**PLANNED UNIT DEVELOPMENT
& SUBDIVISION STAFF REPORT****Date: October 6, 2011****DEVELOPMENT NAME**

Hallmark at Mobile

Hallmark at Mobile Subdivision

Planned Unit Development Approval to allow multiple buildings on a single building site to include four multi-story apartment buildings with a total of 92 units and a clubhouse, and Subdivision approval to create a legal lot of record and a common area from an existing metes and bounds parcel.

SITE PLAN

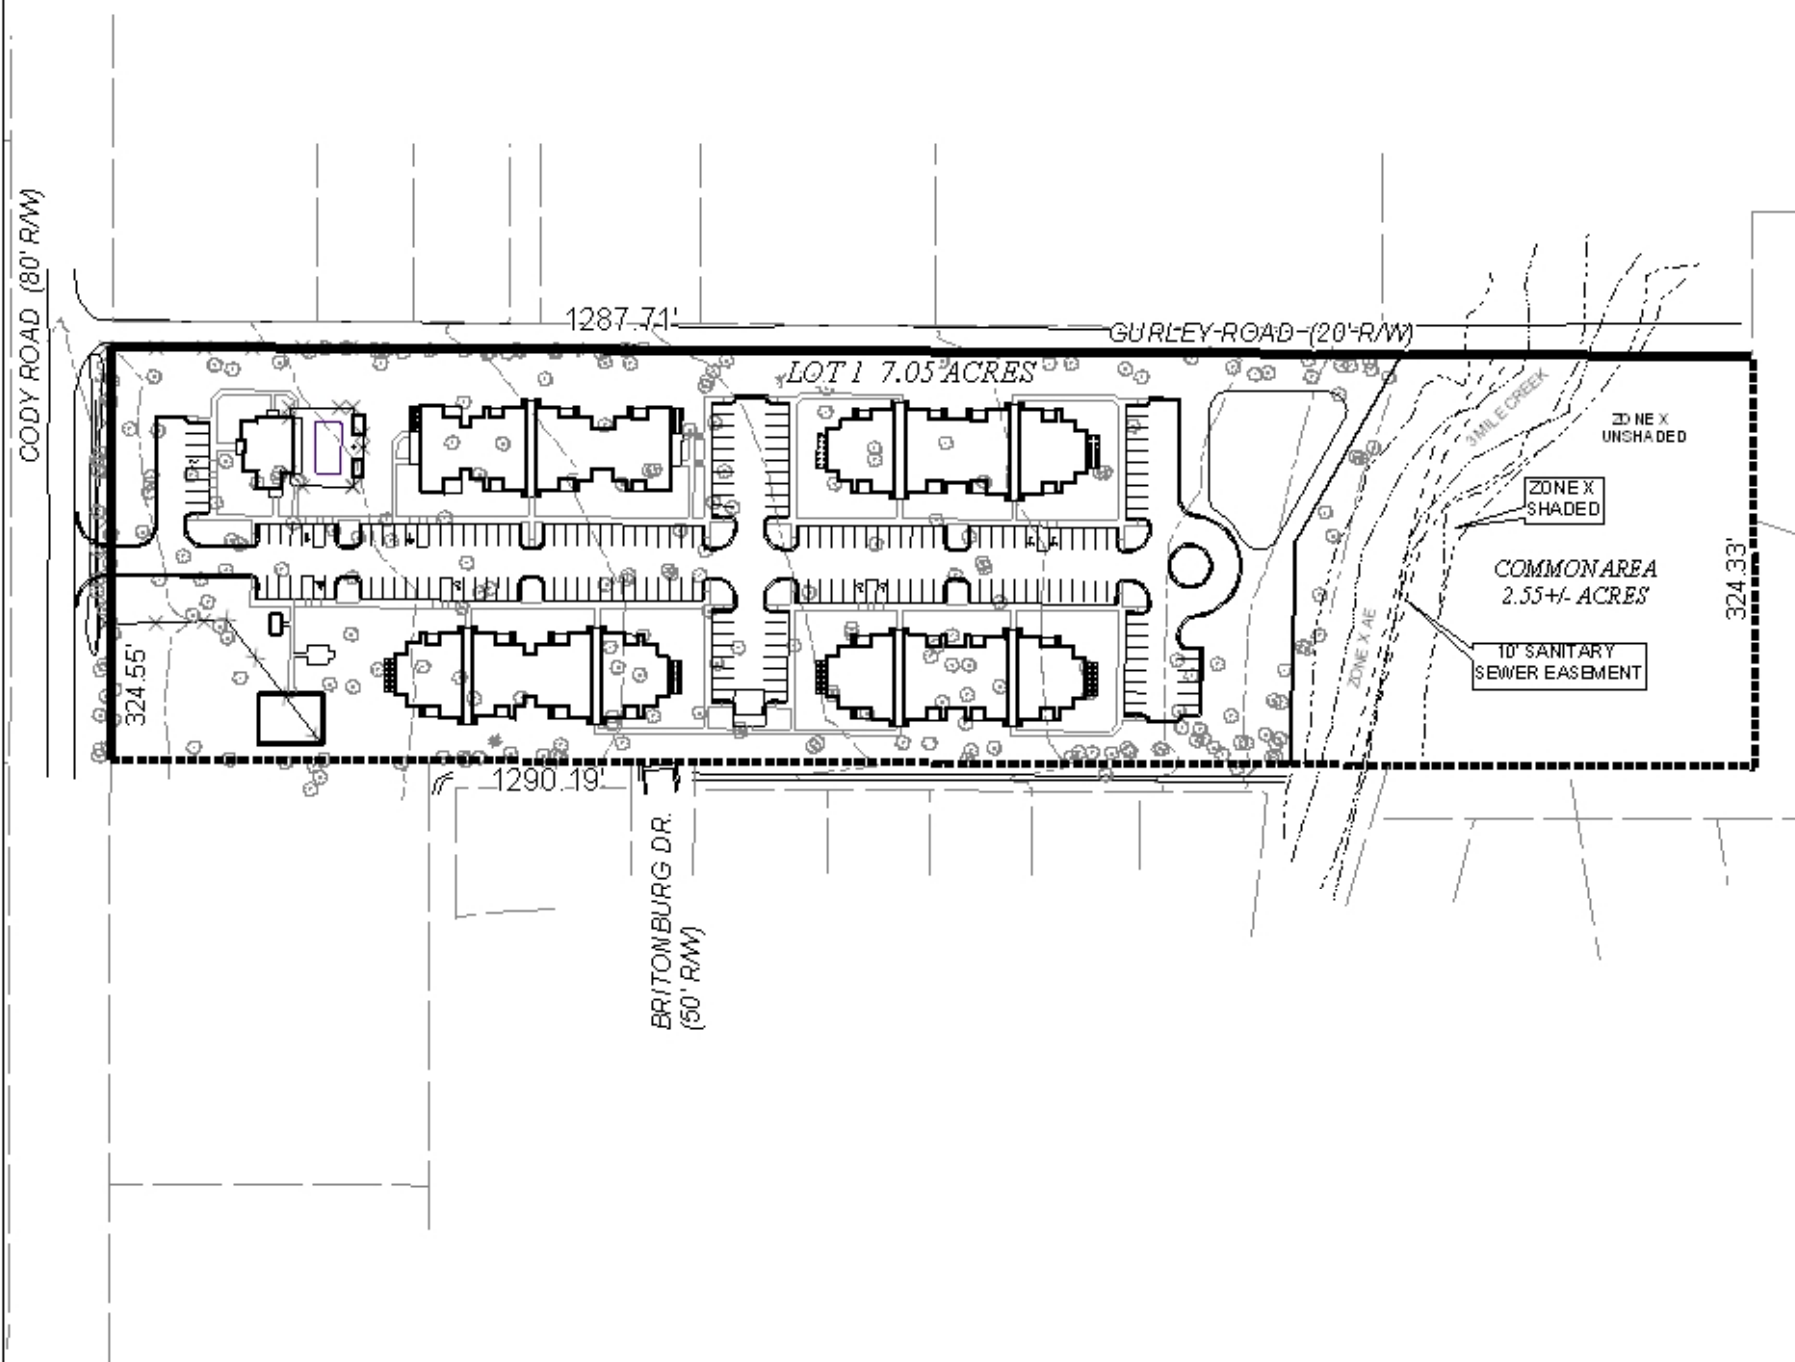
The proposed lot, as depicted, meets the minimum size and frontage requirements as regulated by the Subdivision Regulations. The 25-foot minimum building setback line is not depicted, and this should be depicted along Cody Road North. A 20-foot minimum building line should be depicted along Gurley Road and Britonburg Drive, due to their status as minor streets, and the fact that the lot is a corner lot.. The lot area sizes are depicted on the plat in square feet, and these should be retained on the Final Plat, if approved.

Access management for the development is a concern. The site plan, as submitted, depicts a single curb cut for the development to Cody Road North, and no access to any of the other streets. Access to both Gurley Road and Britonburg Drive would not be desirable, as Gurley Road is substandard and primarily single-family residential, and Britonburg Drive is also residential and is a minor residential stub street in an established subdivision. As such, a note should be placed on the Final Plat stating that the site is limited to one curb cut to Cody Road North, with the size, design, and exact location of all curb cuts to be approved by Traffic Engineering and conform to AASHTO standards. A note should also be placed on the Final Plat stating that access to Gurley Road and Britonburg Drive is denied.

No sidewalks are depicted. A city standard sidewalk should be shown along all public rights-of-way, or request a sidewalk waiver from the Planning Commission.

Regarding the layout of the apartment buildings, due to required dedications, some of the buildings locations, as depicted, may be near or on the minimum building setback line, and the applicant should relocate any building that may be over the setback line to obtain compliance. The applicant also did not provide a landscaping and tree planting plan, however, full compliance with the landscaping and tree planting requirements of the Zoning Ordinance will be required. A dumpster is shown on the plans, however, no dumpster enclosure or sanitary sewer connection is depicted, and this should be shown on the site plan. Lastly, a buffer compliant with Section 64-4.D.1. of the Zoning Ordinance should be provided wherever the site abuts residentially zoned property.

- 1) depiction of any required dedications and minimum building setback line on the site plan;
- 2) placement of a note on the site plan stating that the site is denied direct access to Gurley Road and Britonburg Drive;

- 3) placement of all buildings on or behind the minimum building setback line;
- 4) depiction of a proper dumpster enclosure and sanitary sewer connection at the dumpster;

- 5) depiction of a buffer compliant with Section 64-4.D.1. of the Zoning Ordinance wherever the site abuts residentially zoned property;
- 6) compliance with landscaping and tree planting requirements of the Zoning Ordinance;

- 7) depiction of a city standard sidewalk along all public rights-of-way, or request a sidewalk waiver from the Planning Commission;
- 8) compliance with Urban Forestry comments: *"Property to be developed in compliance with state and local laws that pertain to tree preservation and protection on both city and private properties (State Act 61-929 and City Code Chapters 57 and 64). Preservation status is to be given to the 60" Live Oak Tree located on the South West side of Lot 1. Any work on or under this tree is to be permitted and coordinated with Urban Forestry; removal to be permitted only in the case of disease or impending danger;"*
